Subject: **ACTIVE TRANSPORTATION PROGRAM – PROJECT SCOPE AMENDMENT – SYCAMORE TRAIL EXTENSION (PHASE 3) PROJECT RESOLUTION ATP-P-2526-09**

PROJECT NAME: Sycamore Trail Extension (Phase 3)
IMPLEMENTING AGENCY: City of West Sacramento
ATP ID: ATP5-03-099M
FEDERAL PROJECT NO.: 5447(053)
PPNO: 03-7889
DATE OF AGENCY/CT COORDINATION MEETING: 8/19/2025
FIELD REVIEW DATE (major only): none needed
APPROVED PROJECT DESCRIPTION: Construct 4100 foot Class 1 trail extension from Phase 2 overpass at Westmore Oaks Elementary School to the intersection of Park Blvd and Stone Blvd.

Subject: City of West Sacramento – Sycamore Trail Extension Phase 3 Scope Change Request

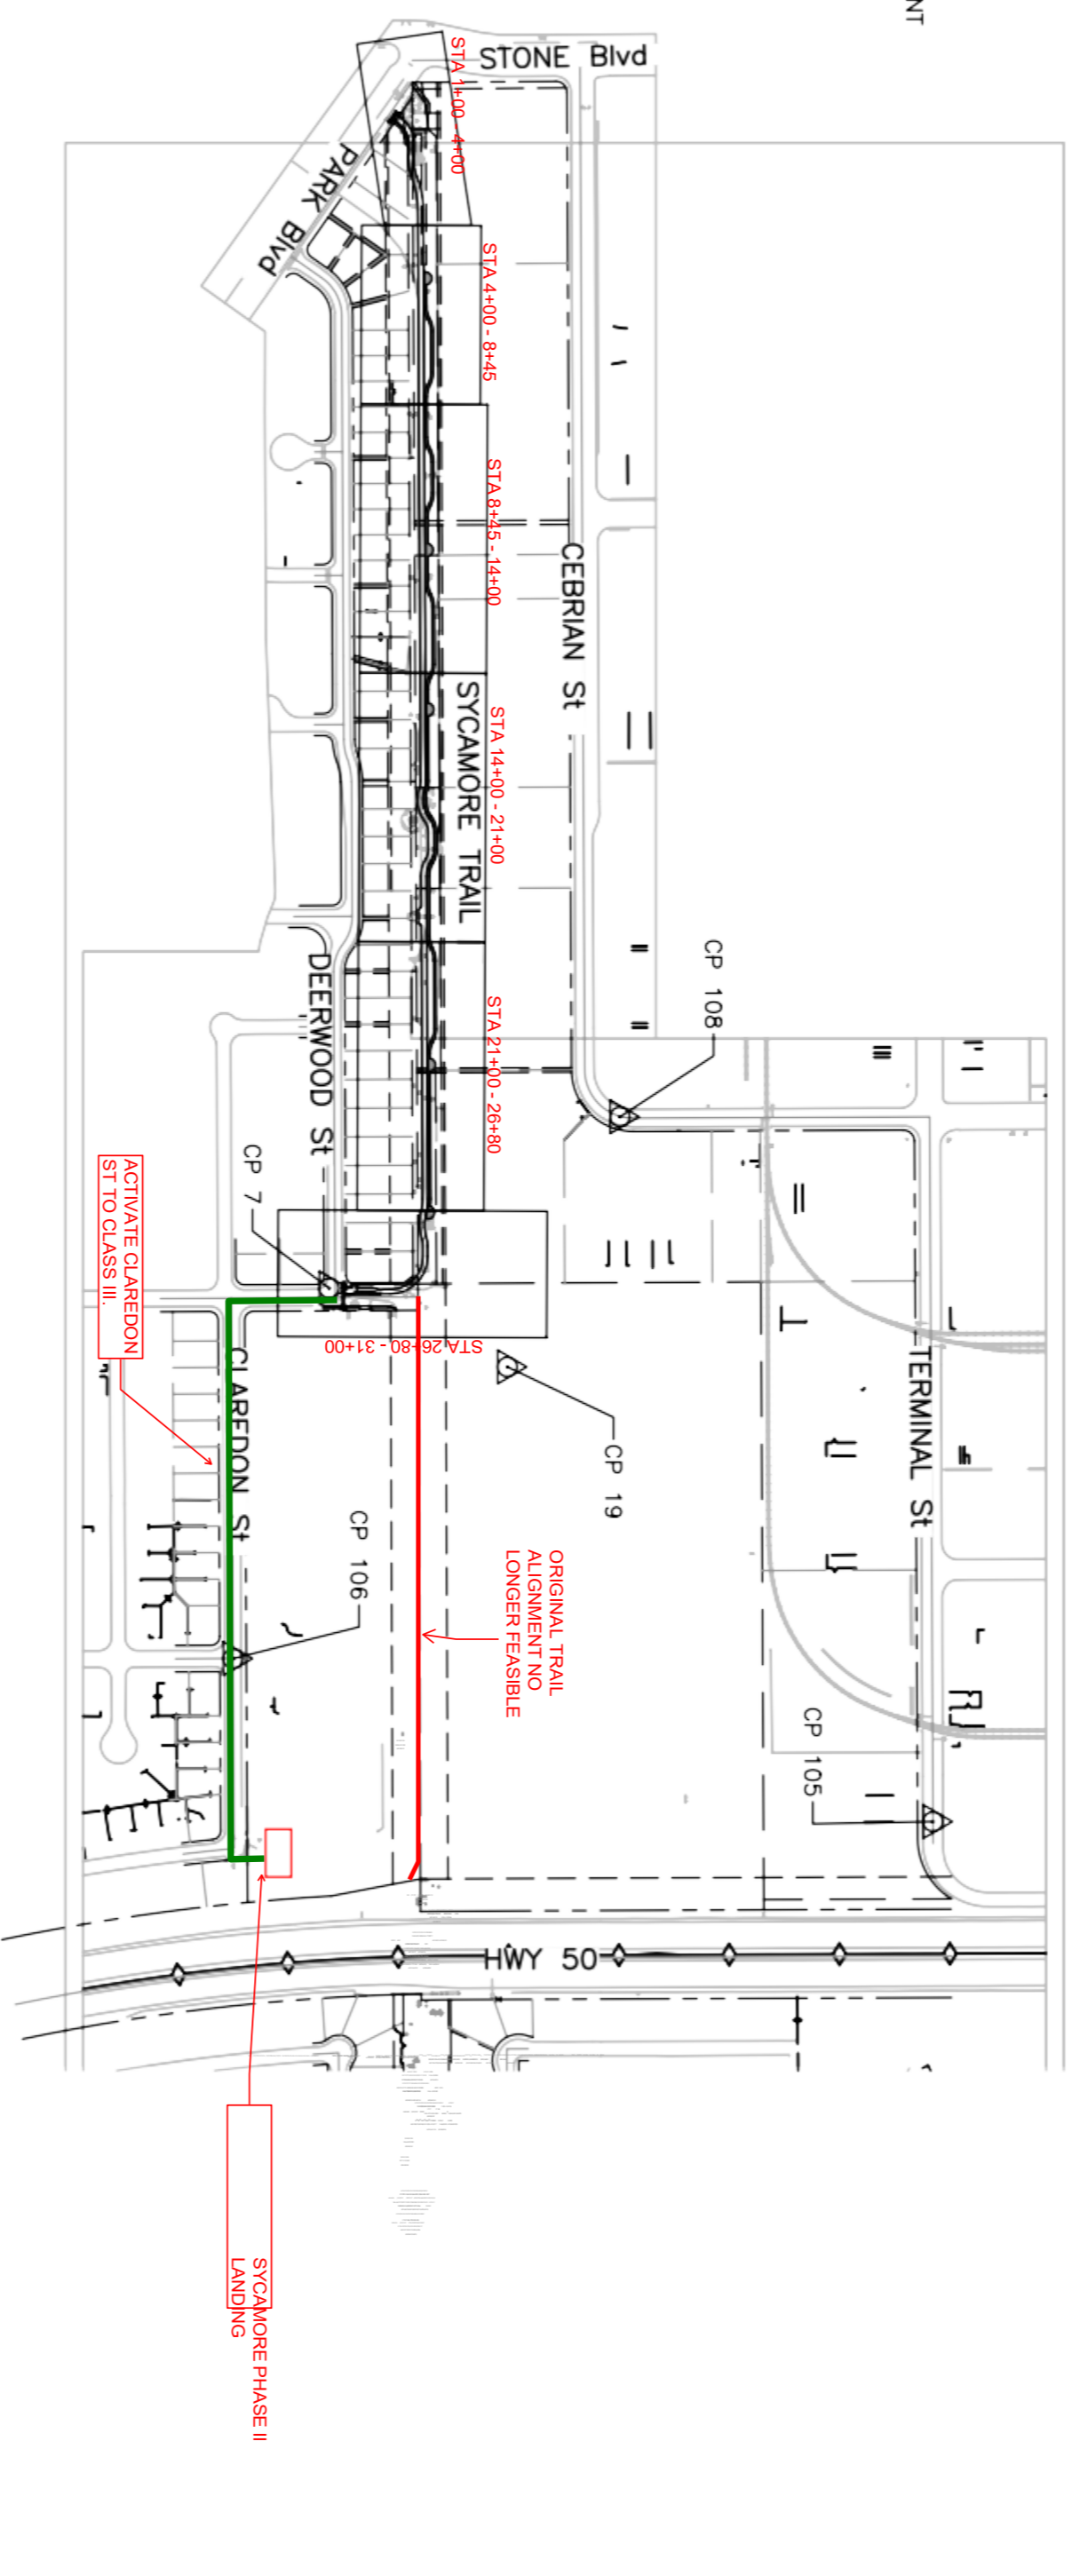
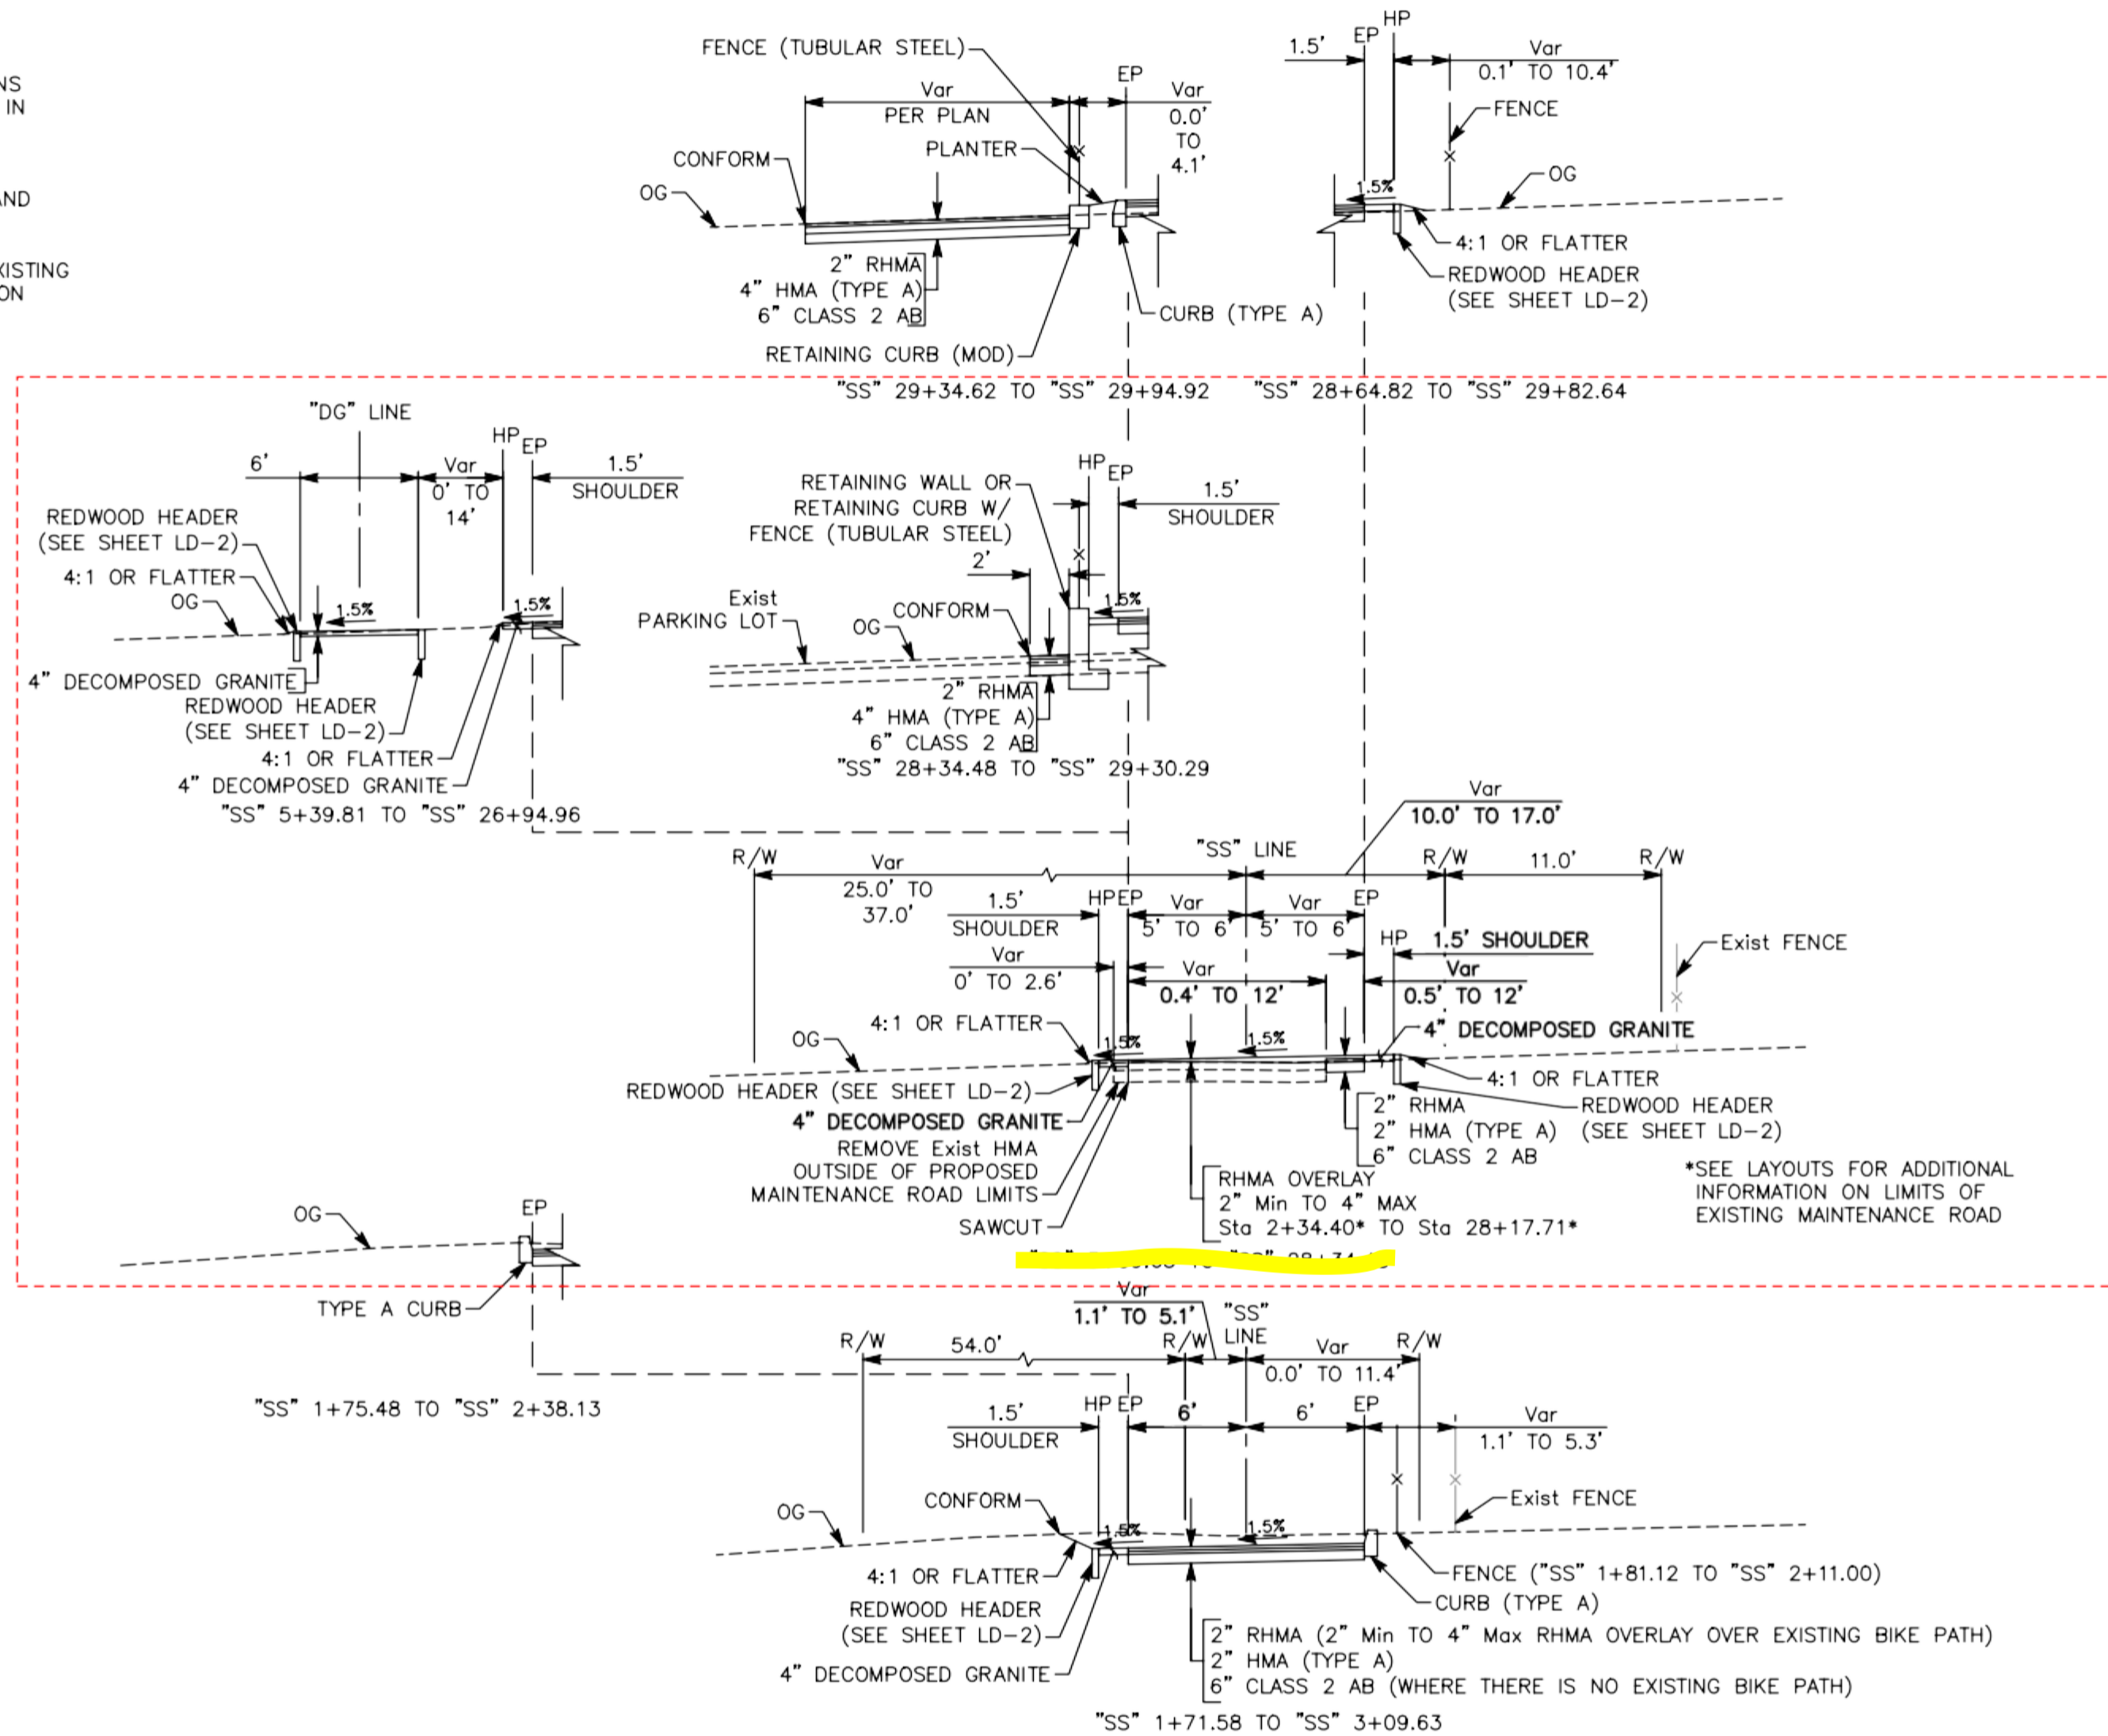
Given these constraints, the City is proposing to adjust the trail alignment by connecting both phases using a publicly accessible low volume residential neighborhood Clarendon Street. The new alignment would follow the same point of origination and destination of the trail and extend to Deerwood Street, where users will be directed to a new Class III facility along Clarendon Street that connects to the recently constructed Sycamore Trail pedestrian overcrossing as described in the previously approved grant application.

With this proposed adjustment, the project scope will reduce the Class I Trail length to 2,900 feet, reduce number of trash cans from nine (9) to six (6), modify all picnic tables to benches, and add 1,400 feet of Class III facilities, including pavement markings and additional wayfinding signs.
